Bearing temperature drift on the HX-400 pump series

Technical Note TN-2026-014 · Halvorsen Fluid Systems, Reliability Engineering

Document	TN-2026-014, revision A
Issued	12 March 2026
Author	Ingrid Moe, Reliability Engineering
Applies to	HX-400, HX-420 and HX-460 centrifugal pumps
Status	Released for field service

Figure 1: Drive-end bearing temperature of two HX-420 pumps on the same site, one with the shielded bearing BRG-6207-ZZ and one with the sealed bearing BRG-6207-2RS, over the first 4,000 operating hours.

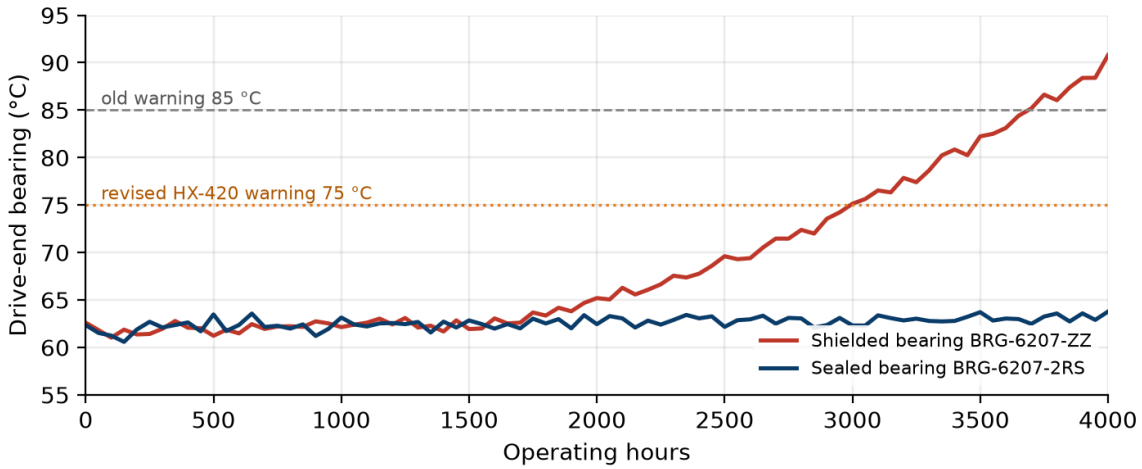
Figure 1 shows the pattern seen across the affected sites. Both pumps start at the same temperature. After about 1,500 hours the pump with the shielded bearing begins to drift upwards and crosses the old warning threshold shortly after 3,000 hours, while the pump with the sealed bearing stays within two degrees of its starting value.
